Troubleshooting Tips

#11 – Kraus Type A and B SKIL184 Software Swapping

Figure 1

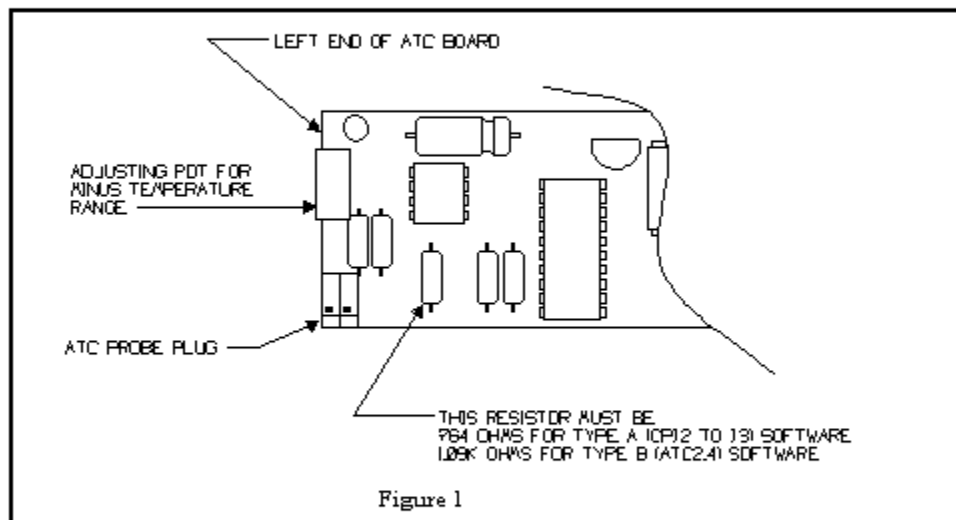
It has come to our attention that Contractors in the field are swapping Type A (CP1.2) Software for Type B (ATC2.4) Software on SKIL 184 ATC Boards, or visa versa, as a result of them changing SKIL 152 Assy 15 Controller Software.

If this is done without changing the resistor closest to the right of the ATC Probe Plug on the SKIL 184 ATC Board (as shown in figure 1) it will result in the plus temperature range being out of compensation. It will be further out the higher the temperature.

The POT on the end of the board adjusts the minus temperature and it also will have to be adjusted in the event of a software type change.

The resistor must be a 784 Ohm for Type A (CP1.2) Software and 1.09K (1090) Ohm for Type B (ATC2.4) Software. Other values will give compensation error.
